Addendum No.: 1

Bid#: 24-10-2

Project Name: Highway LA-21 Lift Station

LIFT STATION
PLAN AND ELEVATION

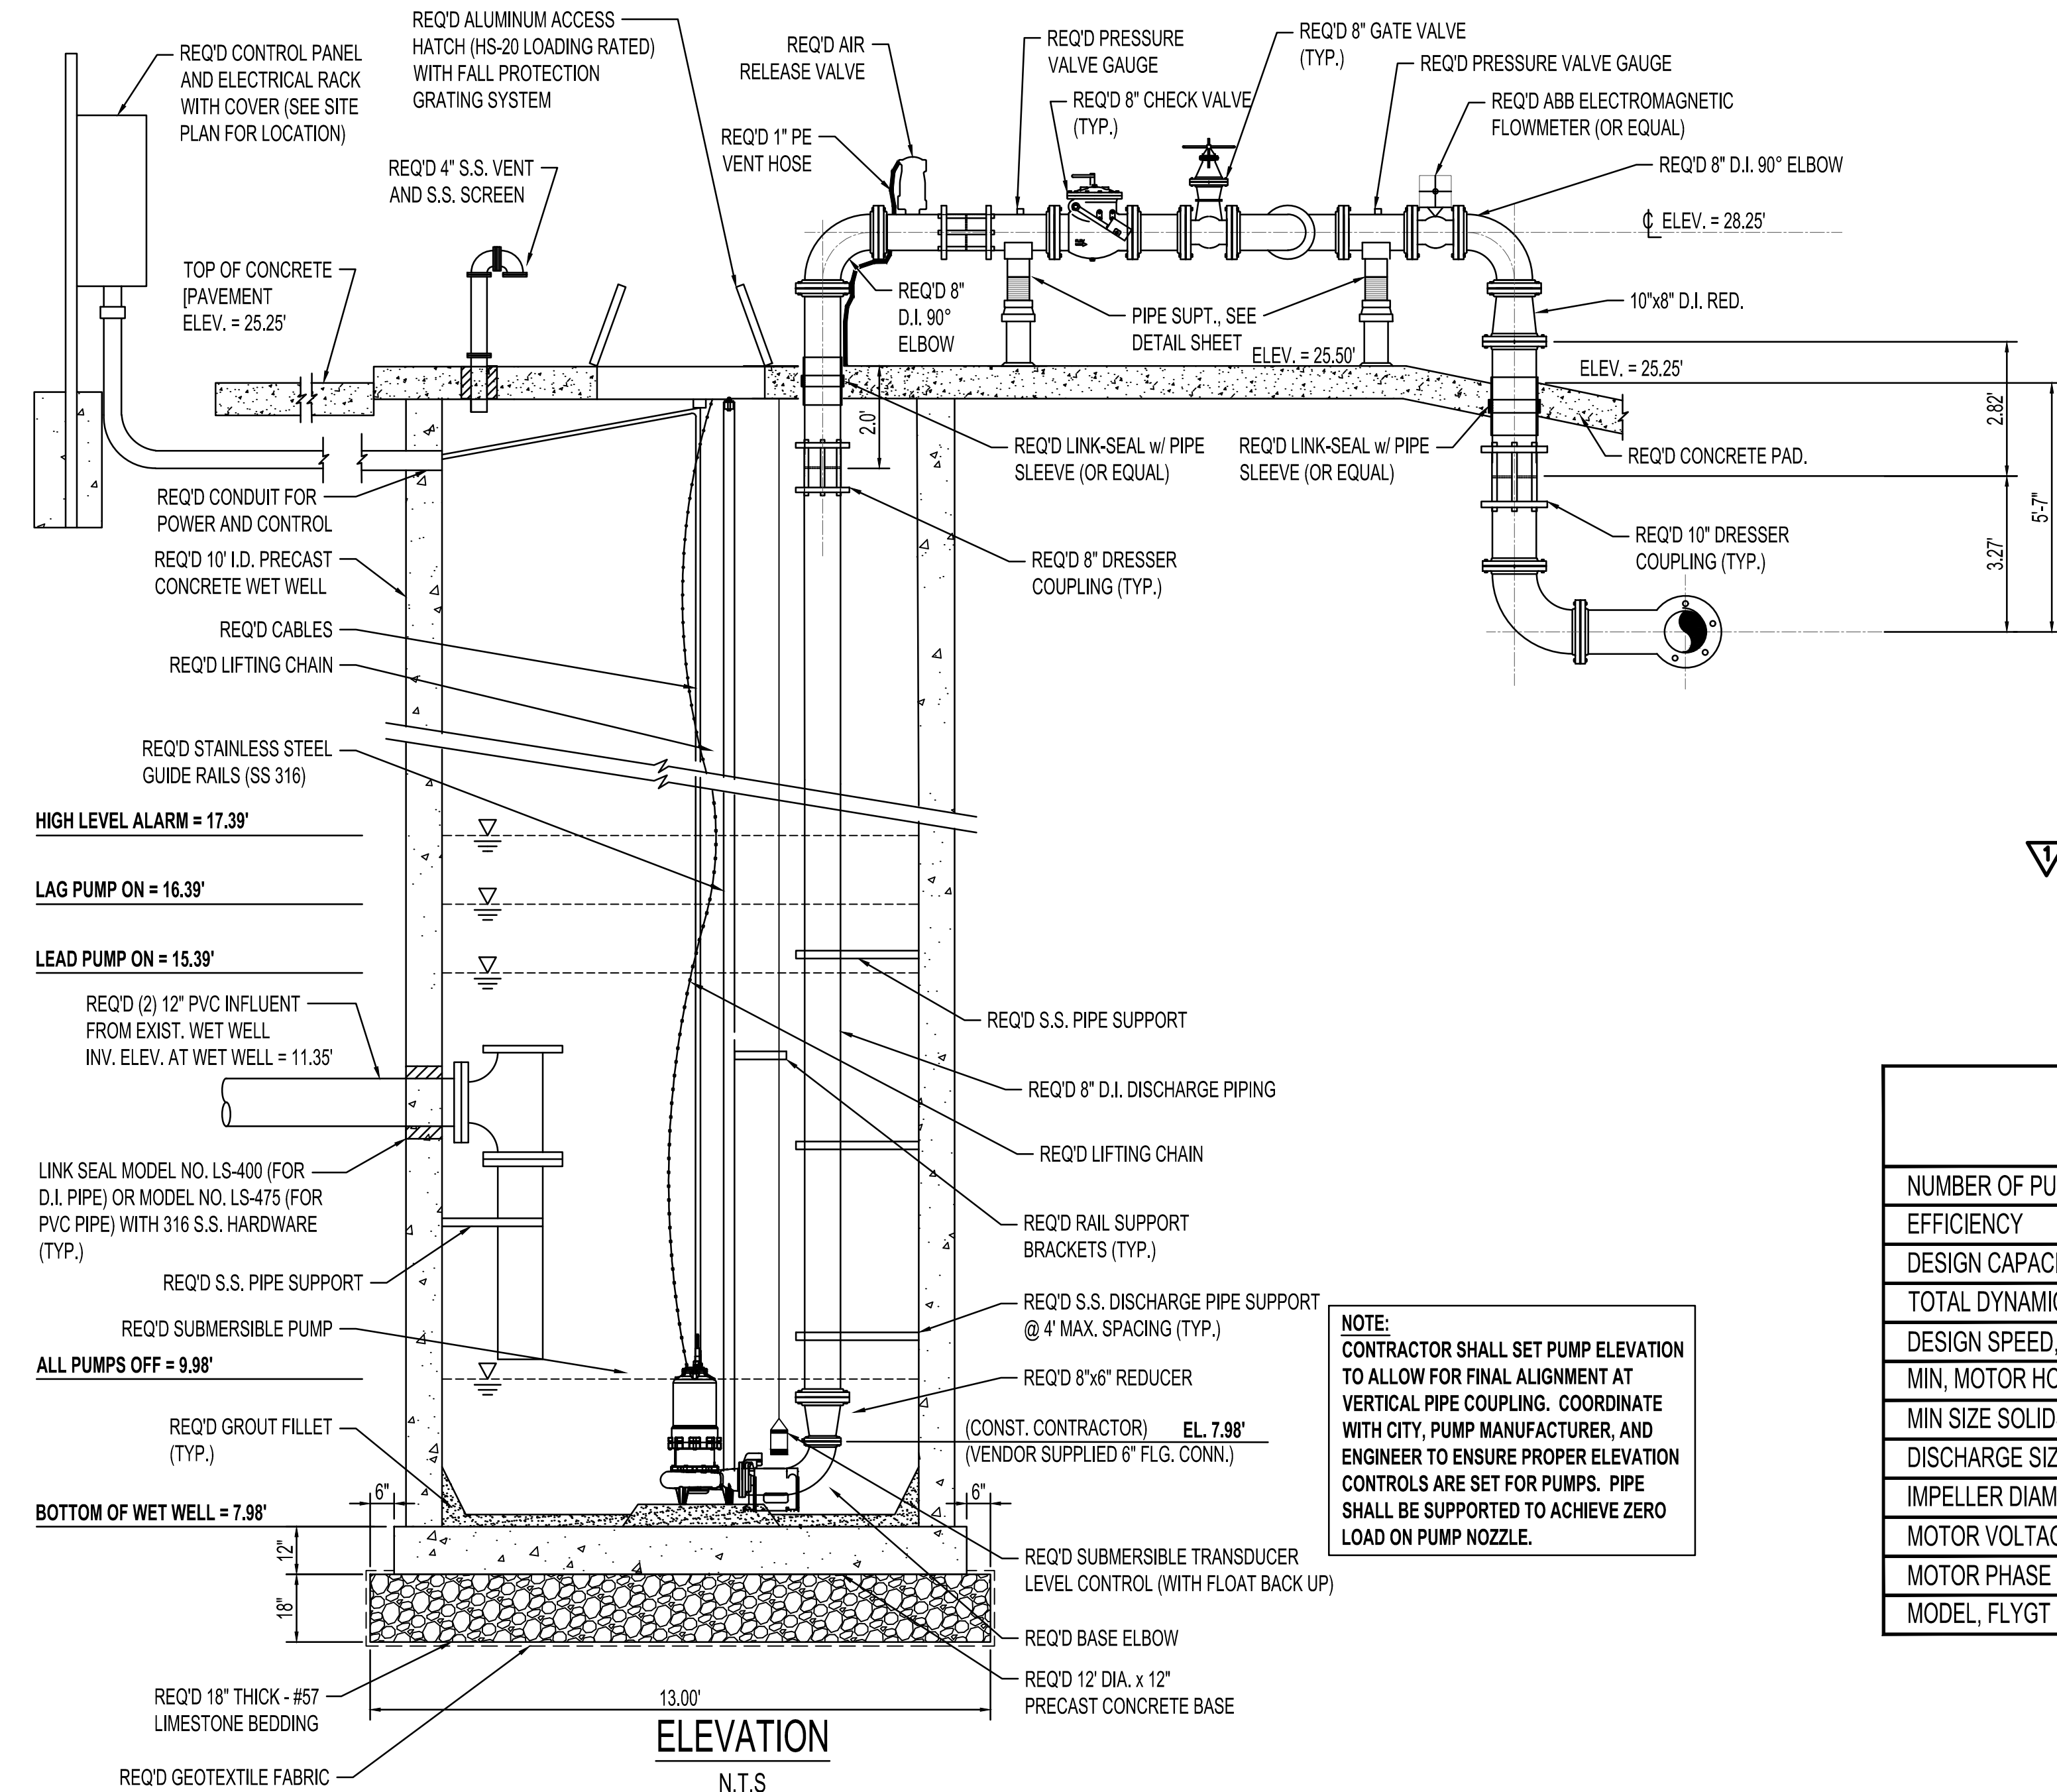
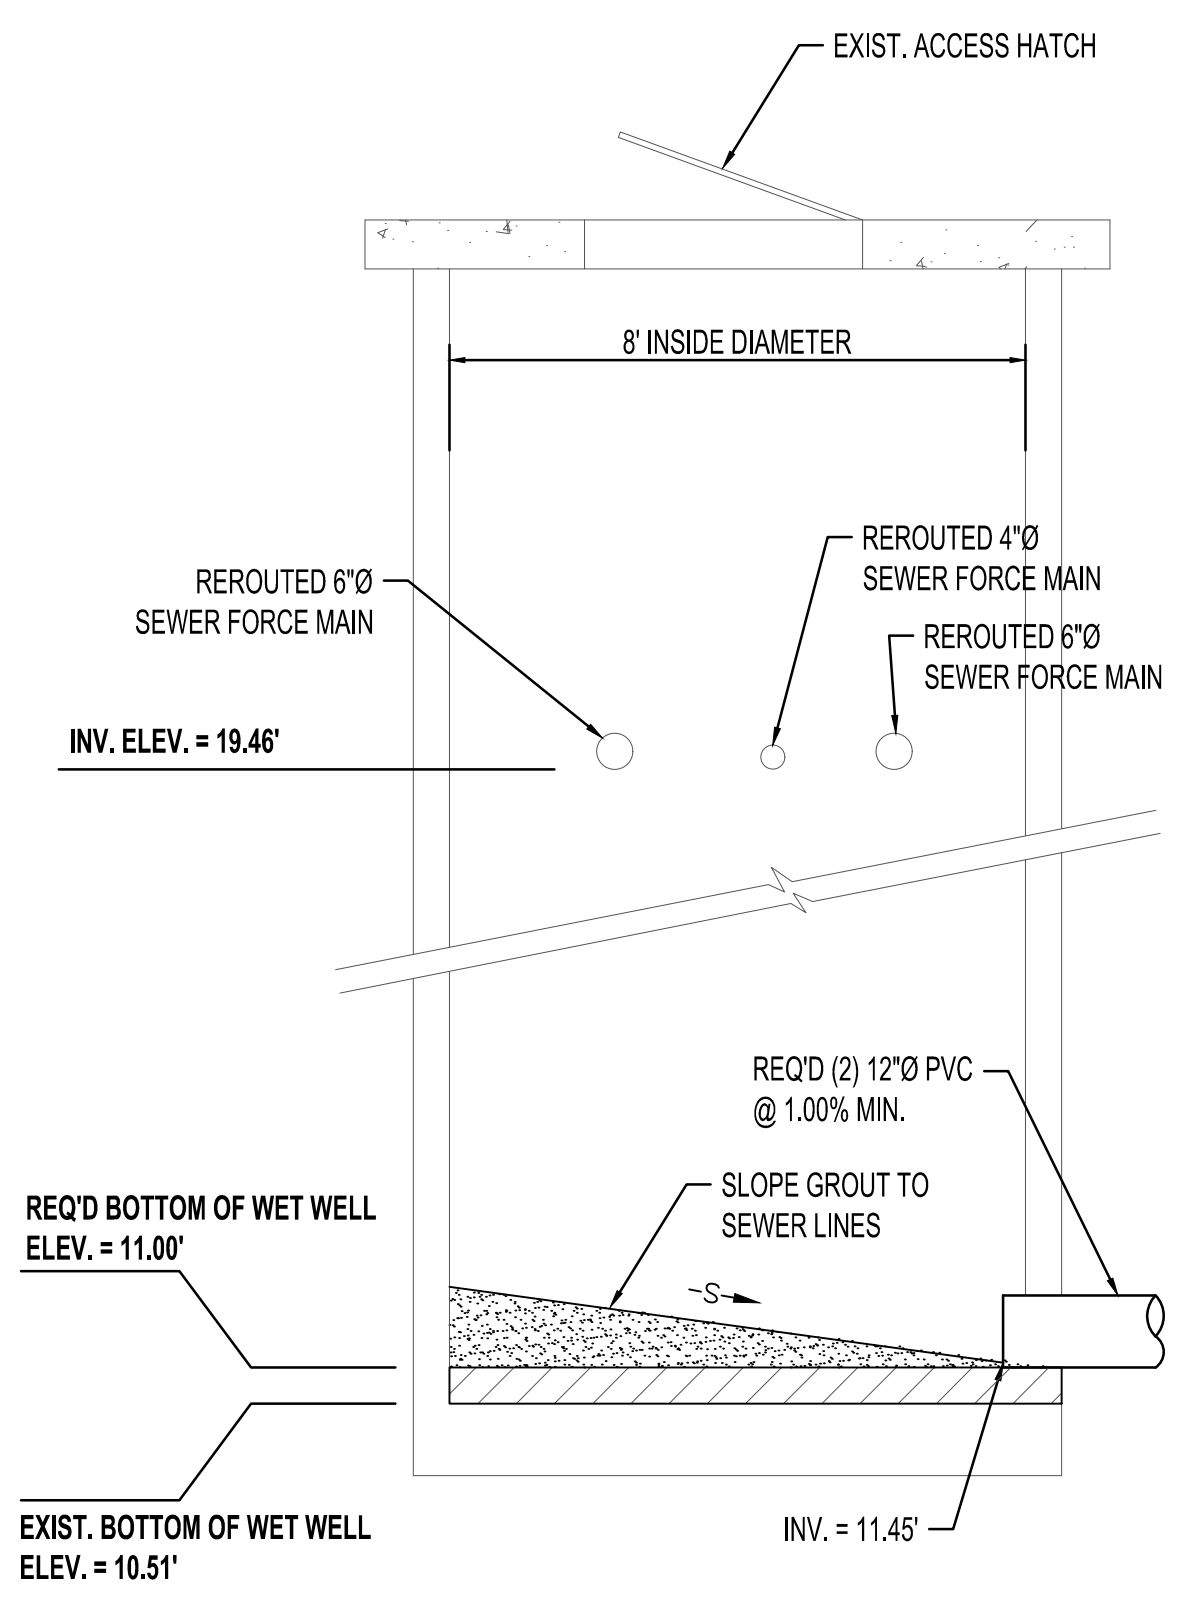
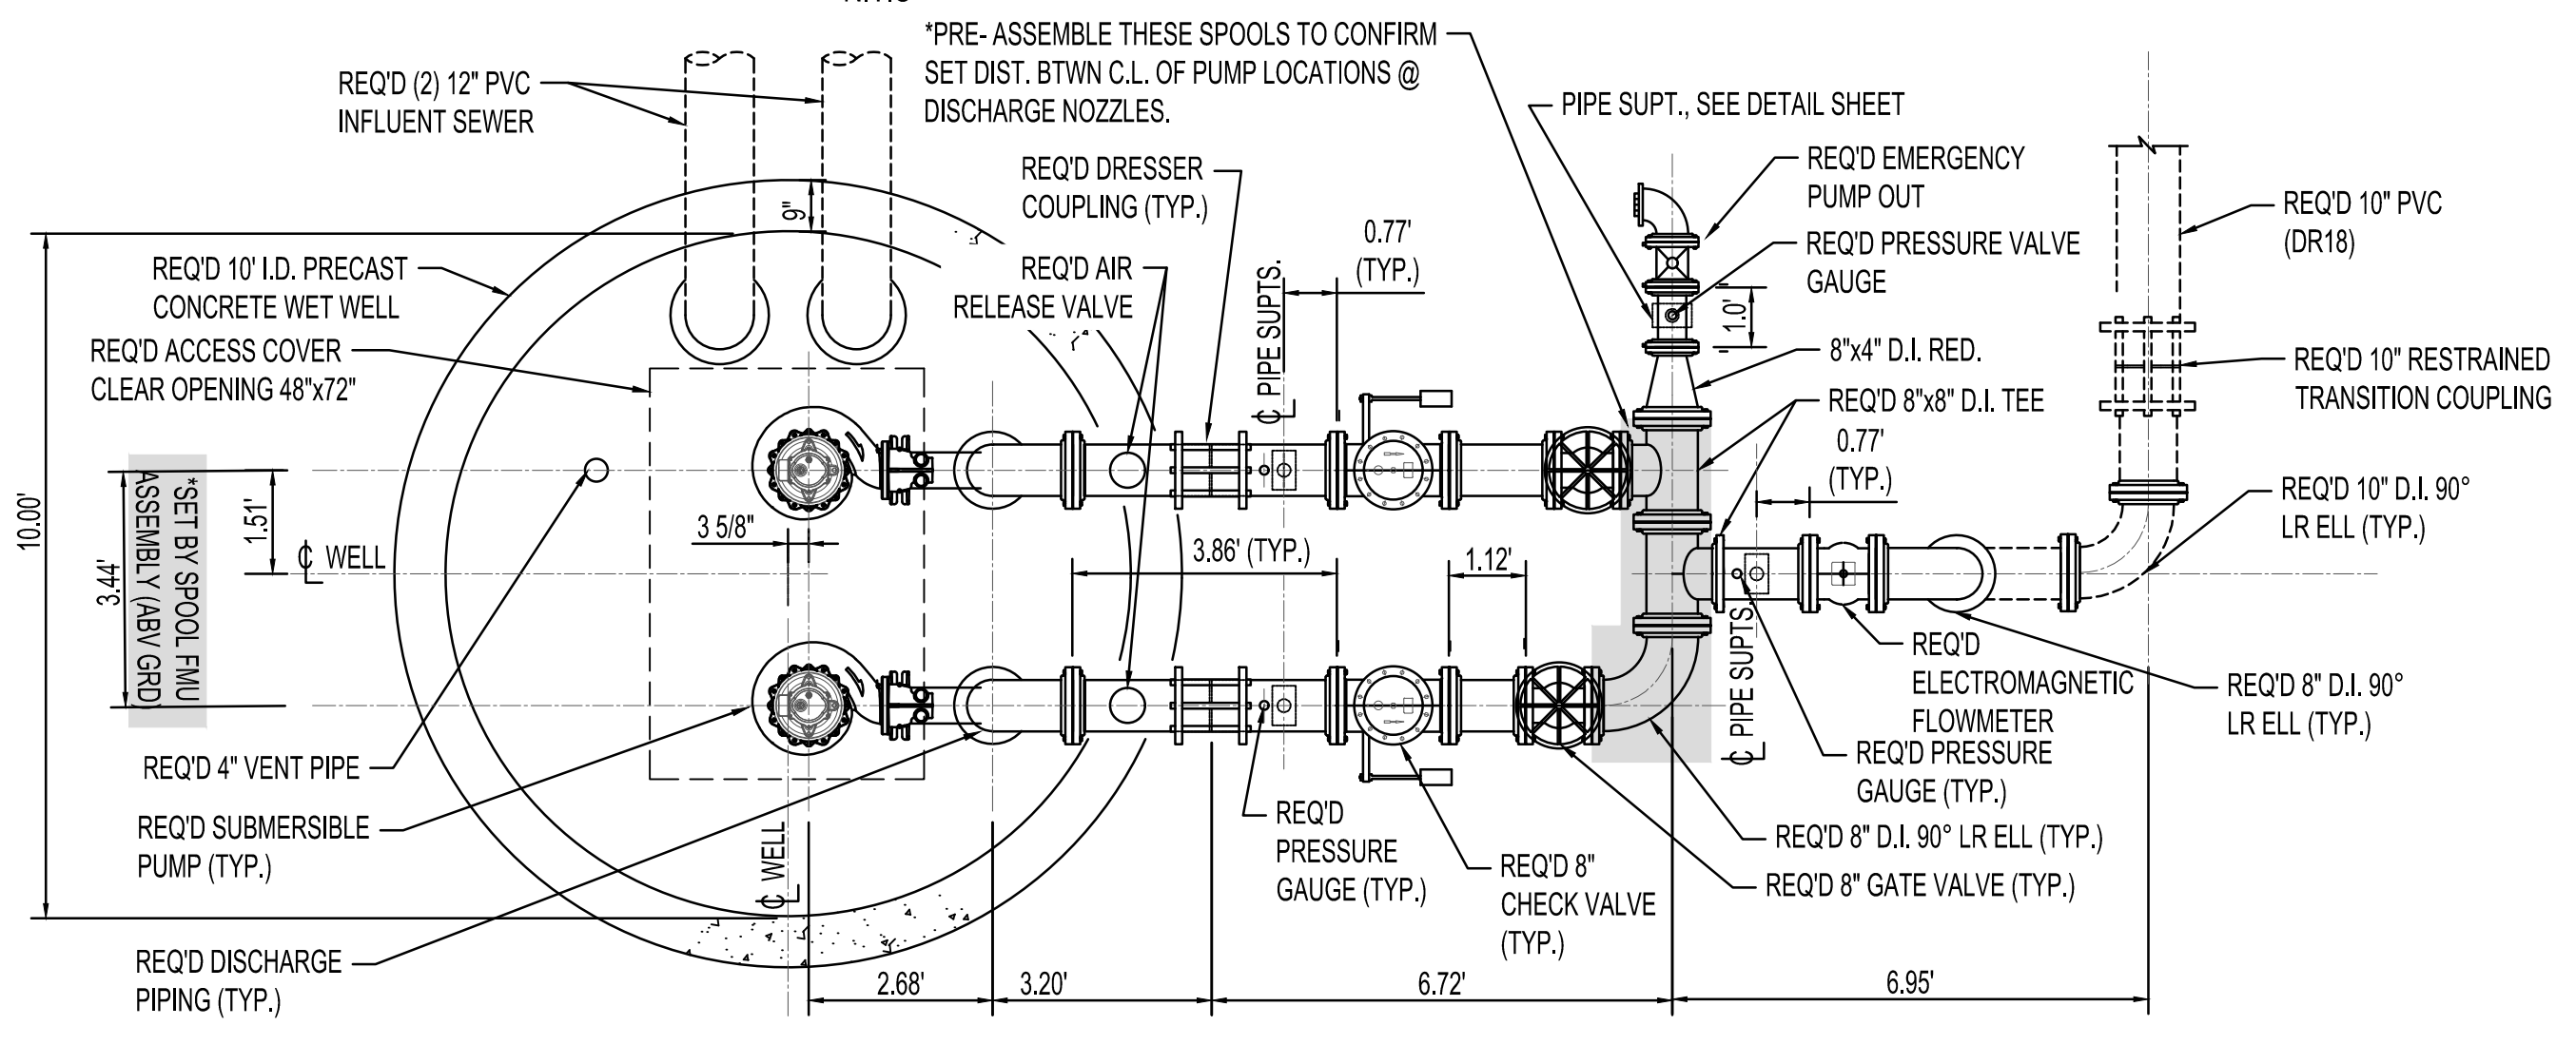
- Question 6:** Can a spec be provided for allowable backfill material for the wet well?
Answer 6: Required backfill material shall be Compacted Granular Material (River Sand), min. density 95% Standard Proctor (ASTM D698), placed in 12” max. layers. The Excavation and Backfill requirements apply per Section 02300. Work and backfill shall be included under Item No. 116 – 10’ I.D. Concrete Wet Well. See Note 11 under the ‘Notes’ on Sheet 12 – Lift Station Plan and Elevation in this Addendum below.

4. Sheet 12 – Lift Station Plan and Elevation

- Add Note 11 to ‘Notes’:

“Required backfill material shall be Compacted Granular Material (River Sand), min. density 95% Standard Proctor (ASTM D698), placed in 12" max. layers. The Excavation and Backfill requirements apply per Section 02300. Work and backfill shall be included under Item No. 116 – 10’ I.D. Concrete Wet Well.”
